Attachment No. 1 to AEP:NRC:0637G
Donald C.Cook Nuclear Plant, Unit No. 2
Description of Unit 2 Cycle 4 Technical Specification
Change Requests

Attachment No. 2 to AEP:NRC:0637G
Donald C. Cook Nuclear Plant, Unit No. 2
Revised Technical Specification Pages

FIGURE 3.2-2

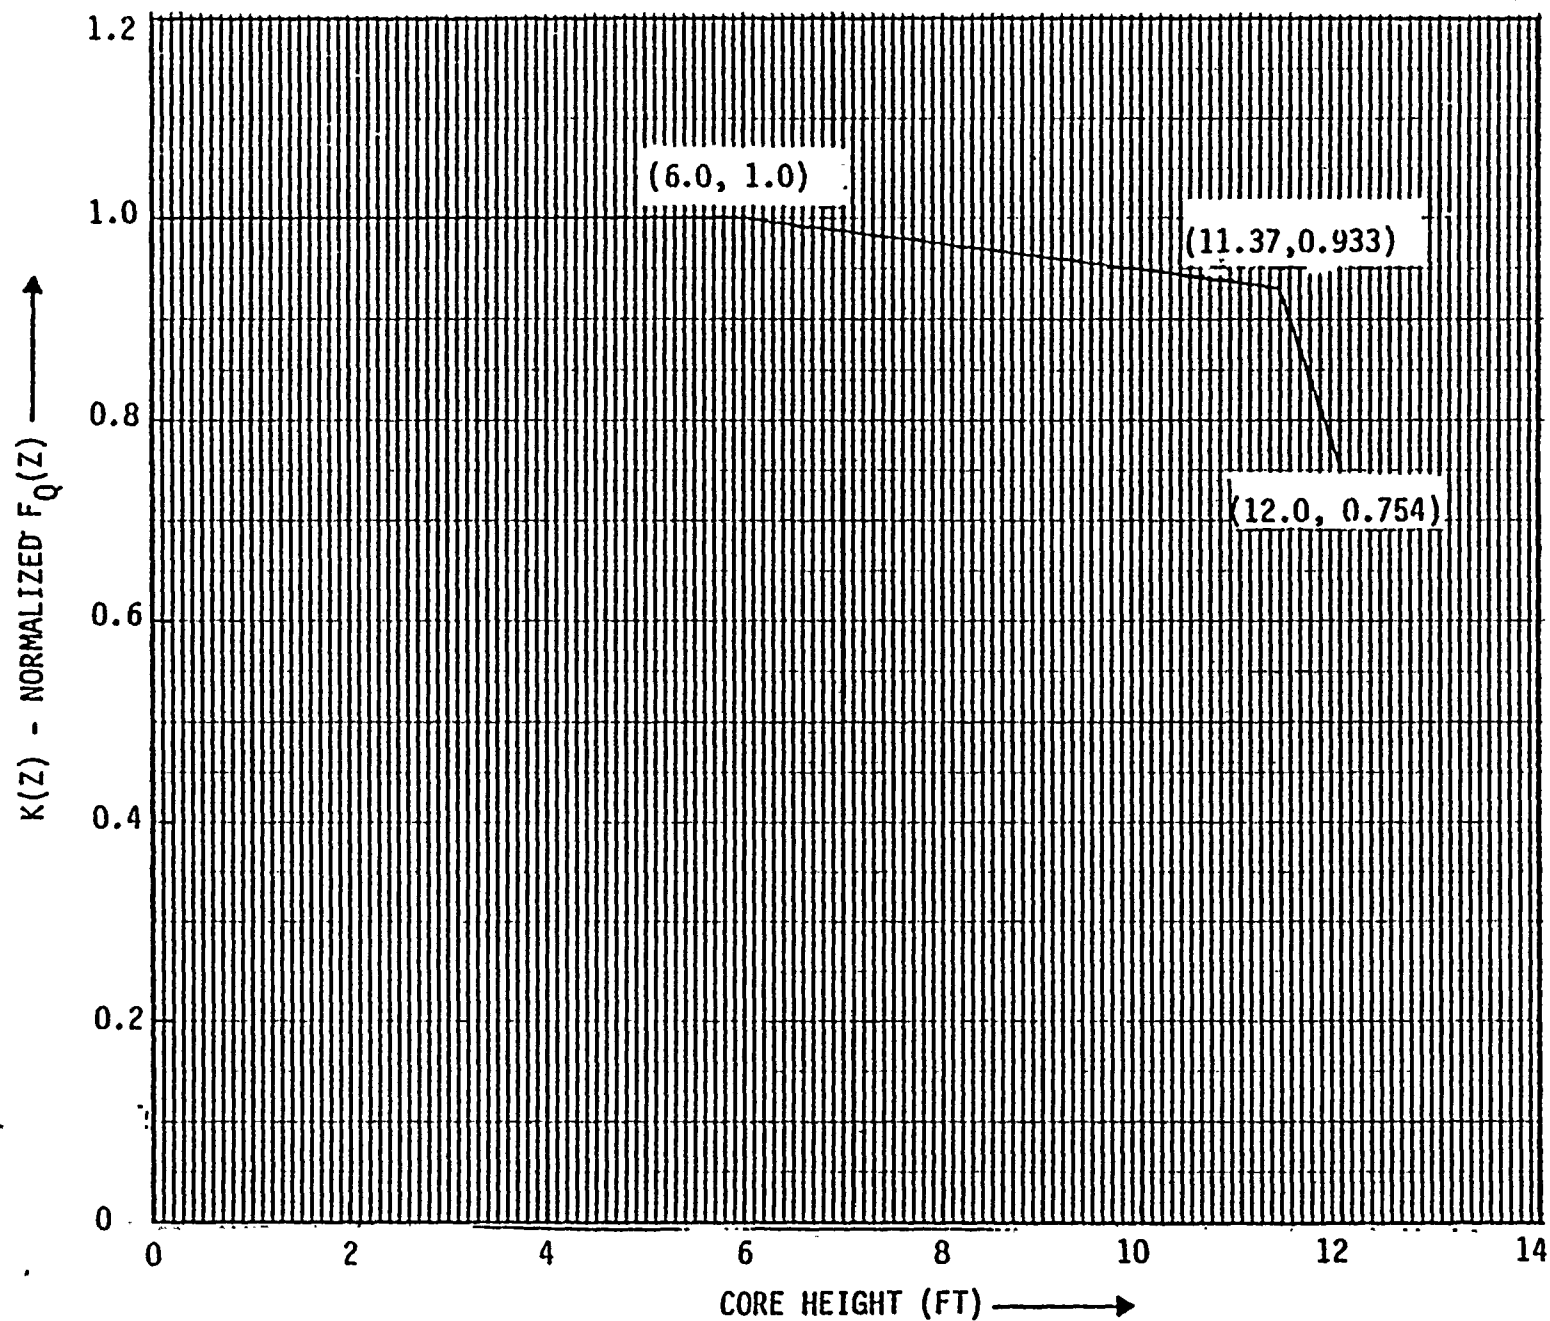
<u>T/S Page No.</u>	<u>Reason for Update</u>
3/4 2-5	$F_Q = 2.04$ - ENC fuel $F_Q = 1.97$ - Westinghouse fuel
3/4 2-6	$F_Q = 2.04$ - ENC fuel $F_Q = 1.97$ - Westinghouse fuel
3/4 2-7	$F_Q = 2.04$ - ENC fuel $F_Q = 1.97$ - Westinghouse fuel
3/4 2-8	Identifies Figure 3.2-2 to be applicable for Westinghouse fuel
3/4 2-8(a)	K(Z) curve for ENC fuel
3/4 2-8(b)	page renumbering - changed from 3/4 2-8(a)
3/4 2-9, 3/4 2-10	Incorporates the $F_{\Delta H}$ limit for ENC fuel in the "R" equation and changes the $F_{\Delta H}$ value for Westinghouse fuel.
3/4 2-11, 3/4 2-12	Figure number 3.2-3 has been changed to 3.2-4 and 3.2-4 has been changed to 3.2-5.
3/4 2-17	$F_Q = 2.04$ - ENC fuel $F_Q = 1.97$ - Westinghouse fuel
3/4 2-18	$F_Q = 2.04$ - ENC fuel $F_Q = 1.97$ - Westinghouse fuel
3/4 2-19	No new information presented pagination page (Action item b. has been moved from 3/4 2-18 to 3/4 2-19).
B 2-2	Separately define limitation on $F_{\Delta H}^N$ for ENC and Westinghouse fuel

and $K(Z)$ is the function obtained from Figure 3.2-2 for Westinghouse fuel and Figure 3.2-2(a) for Exxon Nuclear Company fuel.

FIGURE 3.2-2(a) D. C. COOK UNIT 2, $K(Z)$ - NORMALIZED $F_0(Z)$ AS A FUNCTION OF CORE HEIGHT FOR EXXON NUCLEAR CO. FUEL

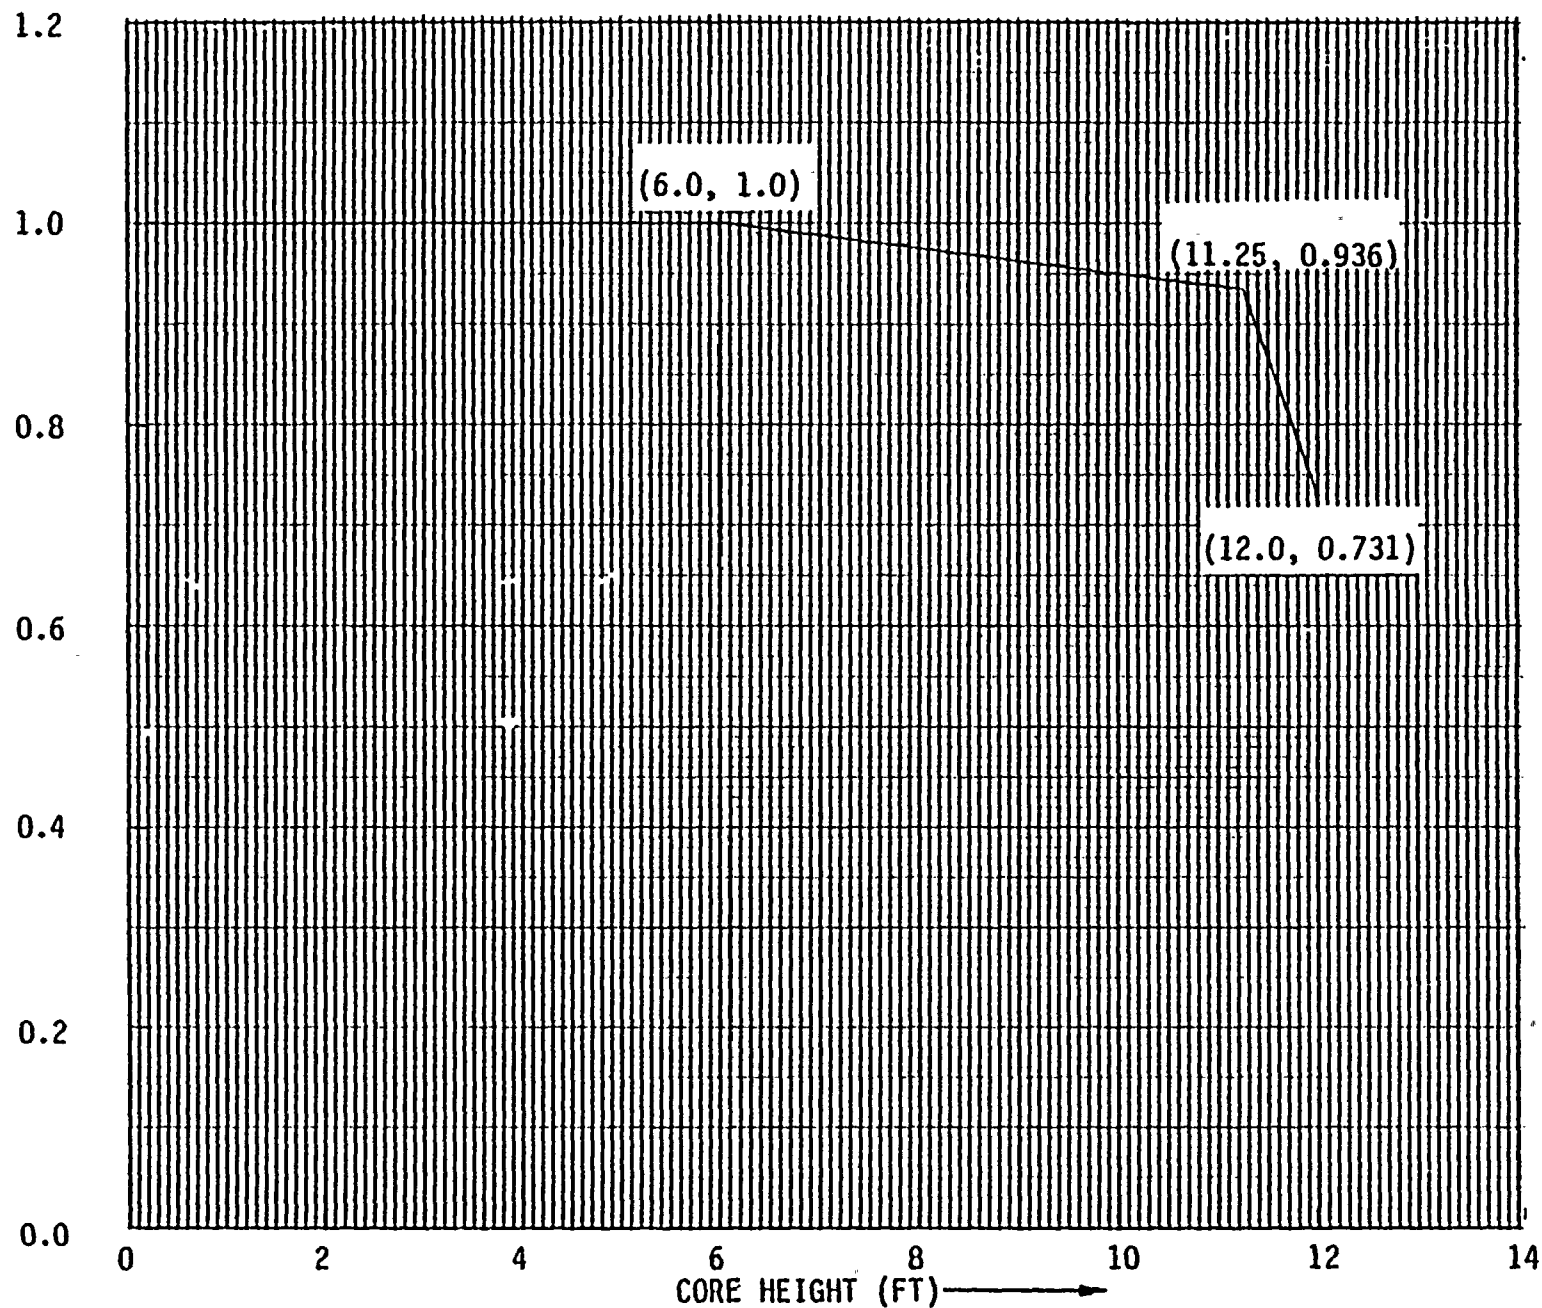
$V(Z)$ is the function defined in Figure 3.2-3 which corresponds to the target band, $K(Z)$ is defined in Figure 3.2-2 for Westinghouse fuel and Figure 3.2-2(a) for Exxon Nuclear Co. fuel, P is the fraction of RATED THERMAL POWER.

FIGURE 3.2-4 RCS TOTAL FLOWRATE VERSUS R - FOUR LOOPS IN OPERATION

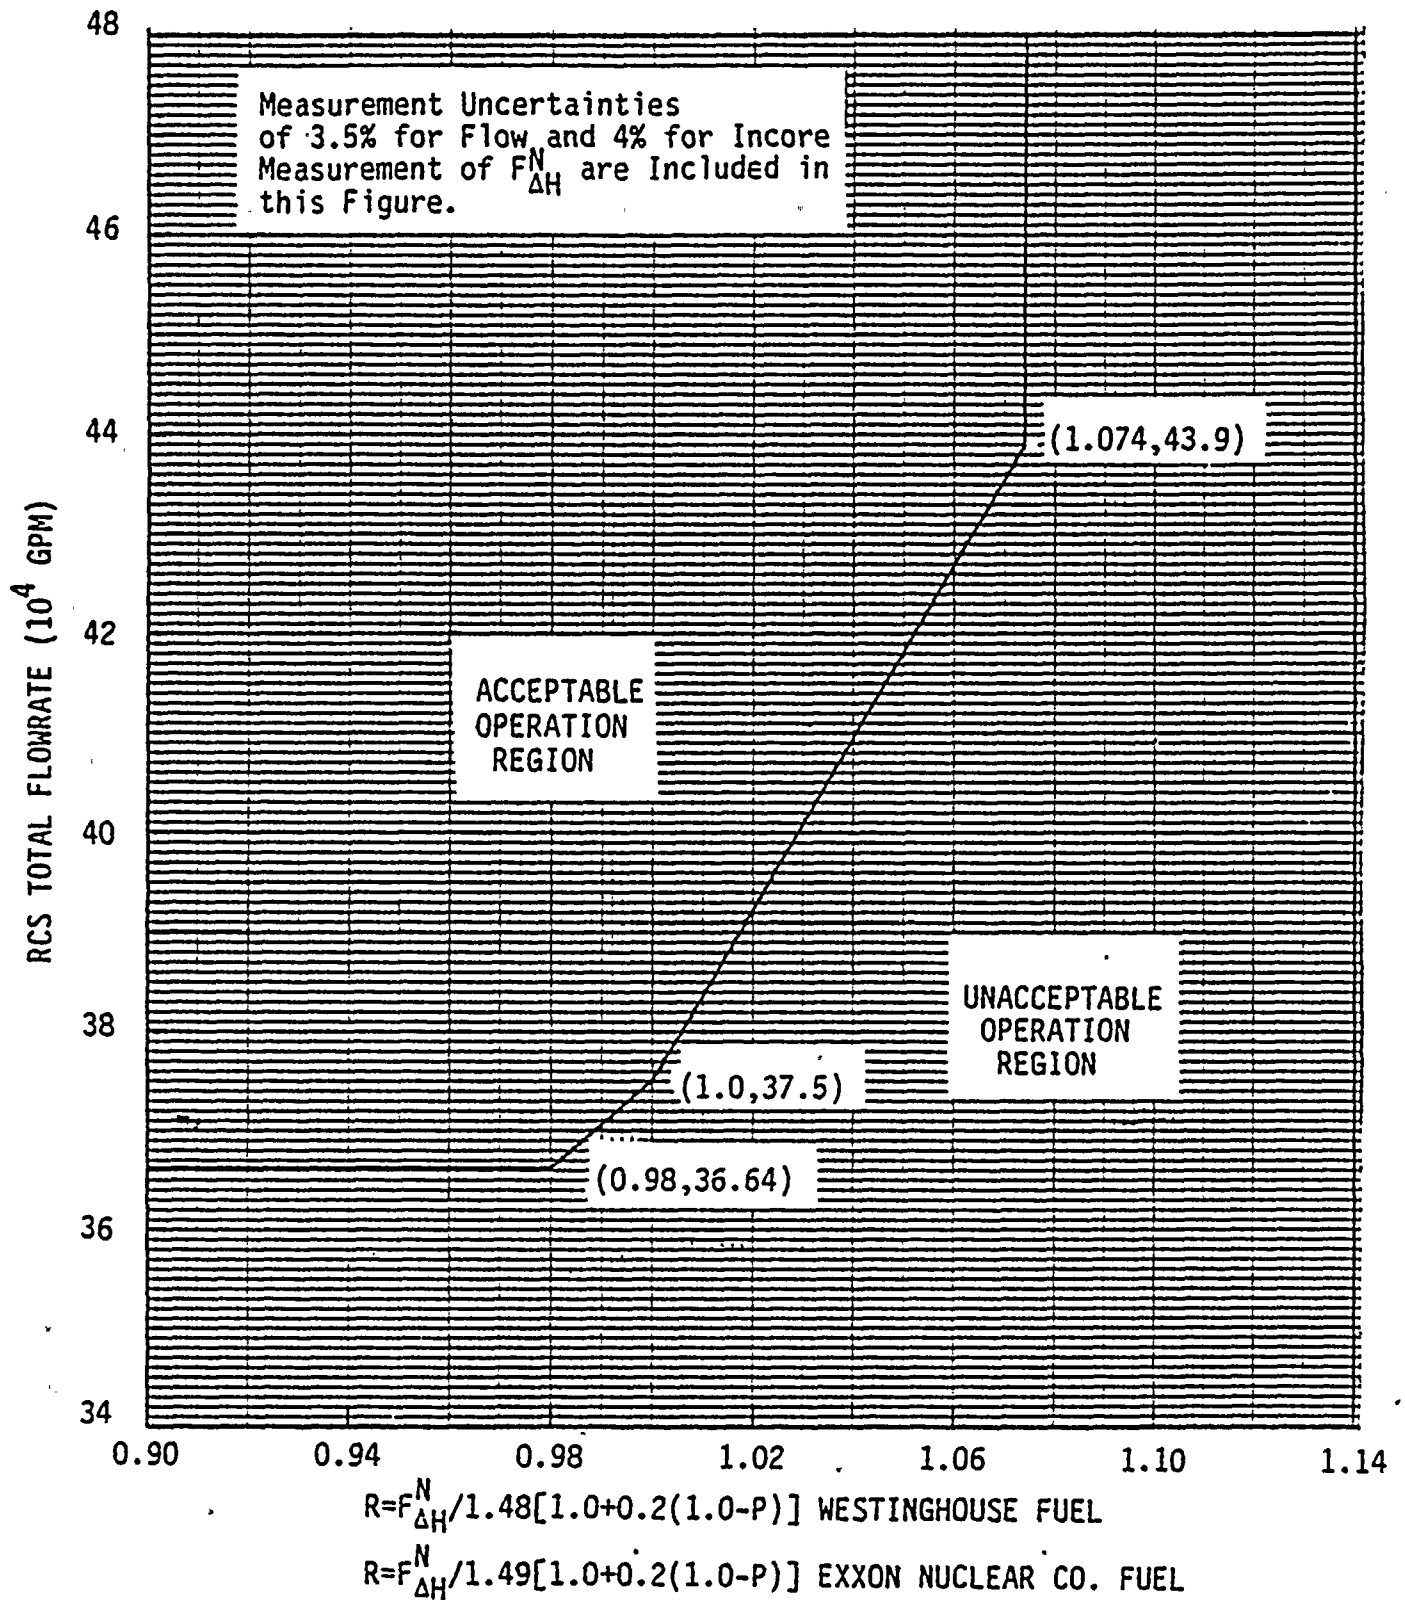
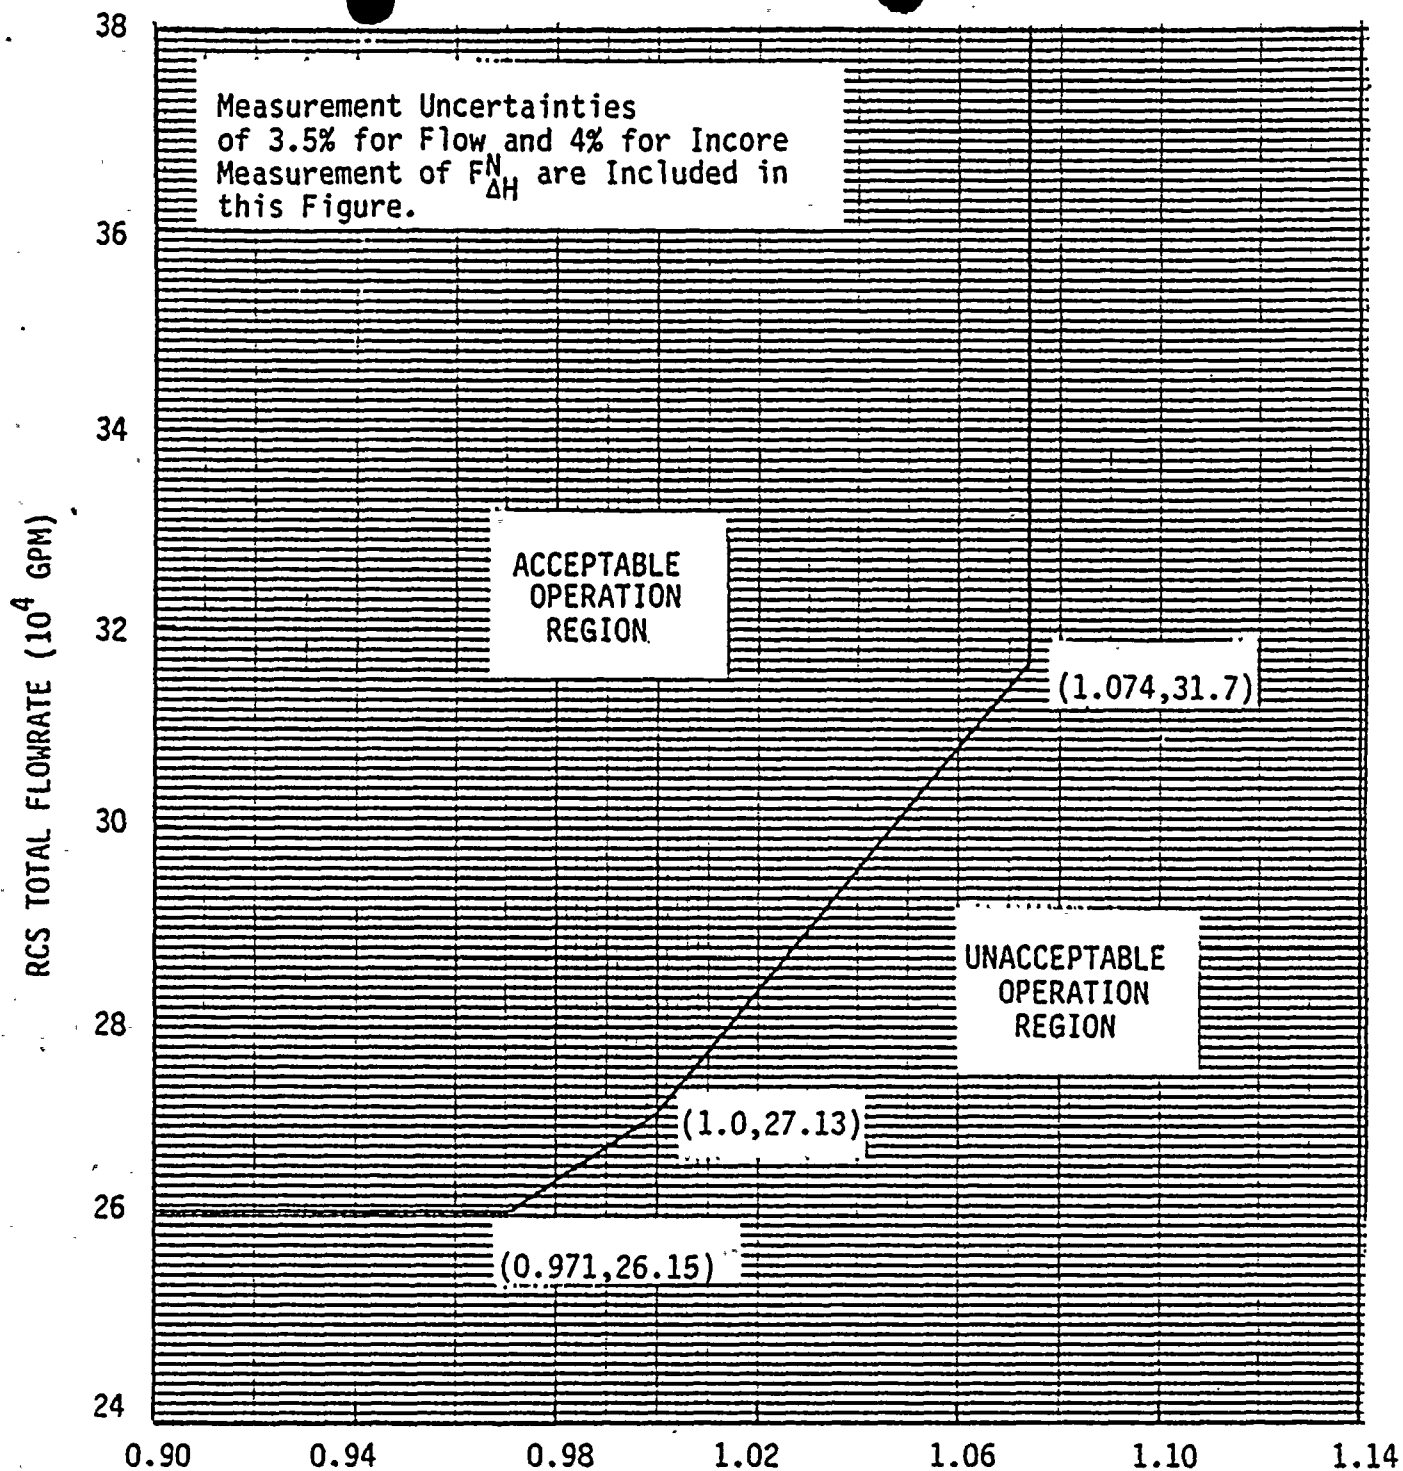
$$R = F_{\Delta H}^N / 1.48 [1.0 + 0.2(1.0 - P)] \text{ WESTINGHOUSE FUEL}$$

$$R = F_{\Delta H}^N / 1.49 [1.0 + 0.2(1.0 - P)] \text{ EXXON NUCLEAR CO. FUEL}$$
